SUBMITTAL REVIEW

Agency Name:	US General Services Administration
Project Name:	Chicago—Loop Station SSA Storage
Project Location:	211 S. Clark St., Chicago IL, 60604
BE No:	16034-17-03

Date Received:	06/09/2017	Specification Section:	Submittal 9-0051
Date Reviewed:	06/12/2017	Description:	Wire Mesh Partitions
Reviewer:	Michael Petti/James Auler

ELEVATION VIEW A

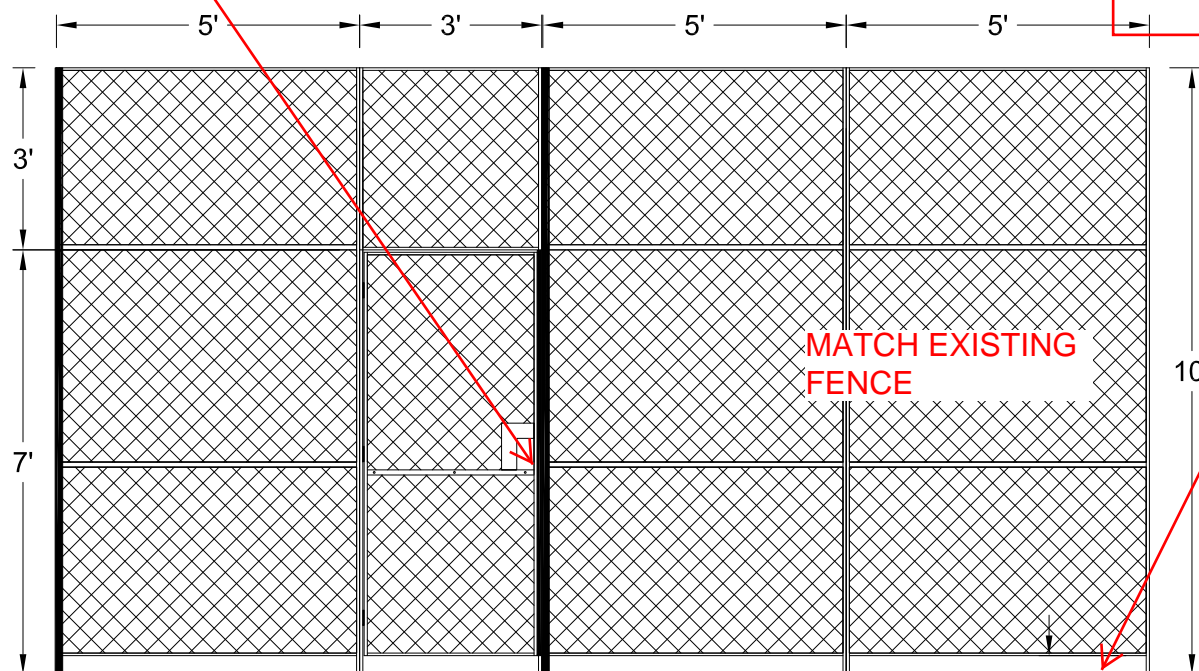
1. SUBMITTAL SHEETS 2 OF 3 AND 3 OF 3, ELEVATION VIEWS A& B:
 - a. NOTE 2, SHEET FP-1 NOTES TO MATCH EXISTING FENCE CONFIRM THE BELOW:
 - b. RAILS AND POSTS NOT IDENTIFIED. BOTTOM POST BRACKETS NOT IDENTIFIED. ANCHORAGE WITH 4 BOLTS NOT INDICATED. CONFIRM ALL MATCH EXISTING AS REQUIRED.
 - c. DRAWINGS NOTE BOTTOM RAIL AS 3.7 INCHES OFF THE FLOOR. EXISTING RAIL IN GSA'S PHOTOS, PAGE 4 OF 8, THE BOTTOM RAIL APPEARS TO BE ON TH FLOOR, OF VERY NEAR THE FLOOR. VERIFY WITH THE GSA THAT THE GAP SHOWN IS ACCEPTABLE FOR THEIR SECURITY NEEDS.
 - d. SUBMITTAL SHEETS 3 OF 3, ELEVATION VIEWS B: VERIFY OVERHEAD CLEARANCE IN EXISTING SPACE FOR FENCE SLIDING HARDWARE SHOWN.
2. V.I.F. ALL DIMENSIONS, TYPICAL
3. HARDWARE SHOWN NOT SPECIFIED. COORDINATE ALL LOCKING HARDWARE AND KEYING WITH THE GSA, AS REQUIRED, SEE NOTES, #3 AND #4, SHEET FP-1.

HARDWARE SHOWN NOT SPECIFIED. COORDINATE ALL LOCKING HARDWARE AND KEYING WITH THE GSA, AS REQUIRED, SEE NOTES, #3 AND #4, SHEET FP-1.

RAILS AND POSTS NOT IDENTIFIED. BOTTOM POST BRACKETS NOT IDENTIFIED. ANCHORAGE WITH 4 BOLTS NOT INDICATED. CONFIRM ALL MATCH EXISTING AS REQUIRED.

DRAWINGS NOTE BOTTOM RAIL AS 3.7 INCHES OFF THE FLOOR. EXISTING RAIL IN GSA'S PHOTOS, PAGE 4 OF 8, THE BOTTOM RAIL APPEARS TO BE ON TH FLOOR, OF VERY NEAR THE FLOOR. VERIFY WITH THE GSA THAT THE GAP SHOWN IS ACCEPTABLE FOR THEIR SECURITY NEEDS.

ELEVATION VIEW B

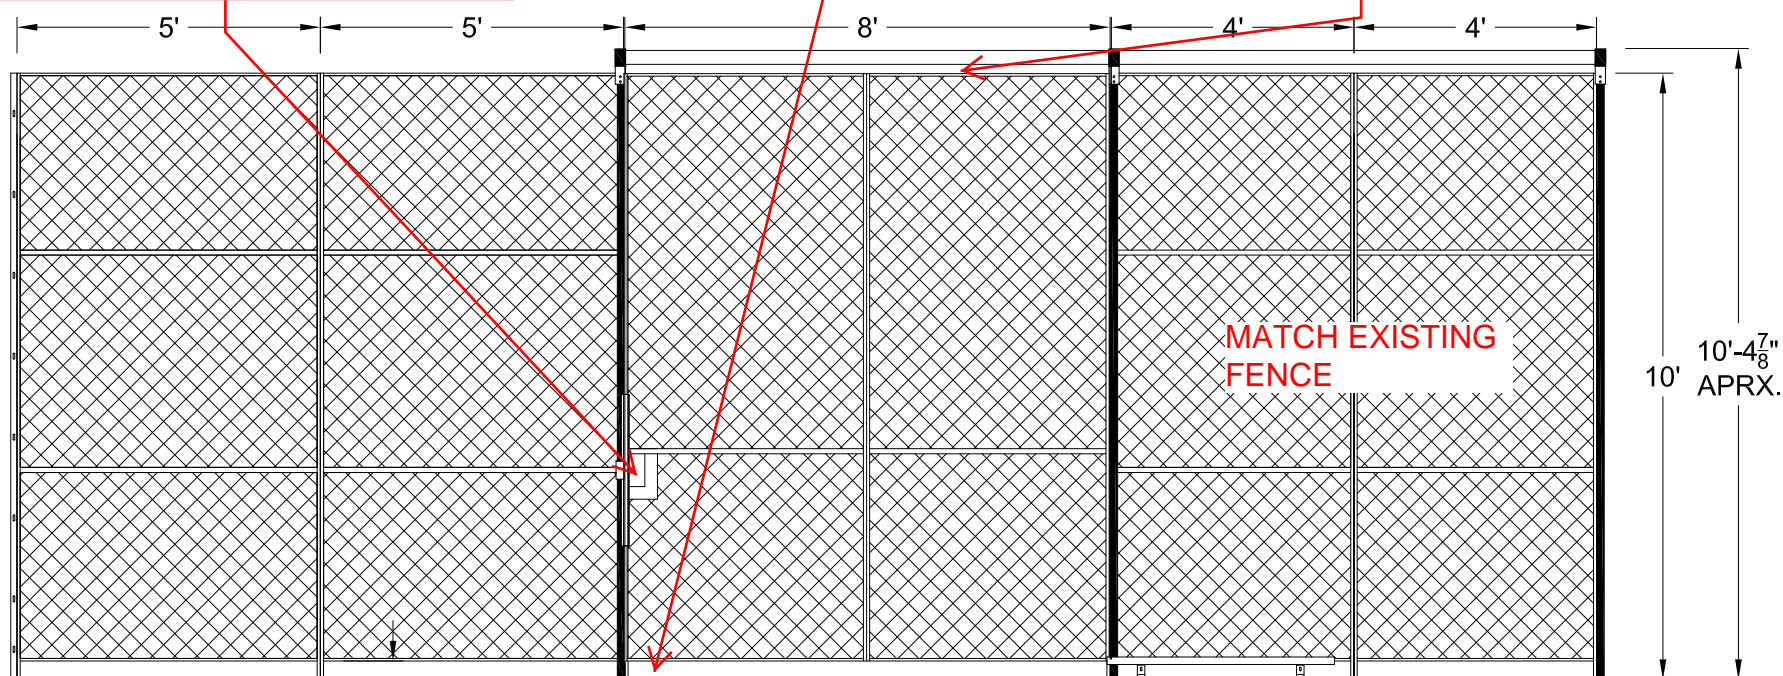
HARDWARE SHOWN NOT SPECIFIED. COORDINATE ALL LOCKING HARDWARE AND KEYING WITH THE GSA, AS REQUIRED, SEE NOTES, #3 AND #4, SHEET FP-1.

RAILS AND POSTS NOT IDENTIFIED. BOTTOM POST BRACKETS NOT IDENTIFIED. ANCHORAGE WITH 4 BOLTS NOT INDICATED. CONFIRM ALL MATCH EXISTING AS REQUIRED.

VERIFY OVERHEAD CLEARANCE

DRAWINGS NOTE BOTTOM RAIL AS 3.7 INCHES OFF THE FLOOR. EXISTING RAIL IN GSA'S PHOTOS, PAGE 4 OF 8, THE BOTTOM RAIL APPEARS TO BE ON TH FLOOR, OF VERY NEAR THE FLOOR. VERIFY WITH THE GSA THAT THE GAP SHOWN IS ACCEPTABLE FOR THEIR SECURITY NEEDS.

MATCH EXISTING FENCE
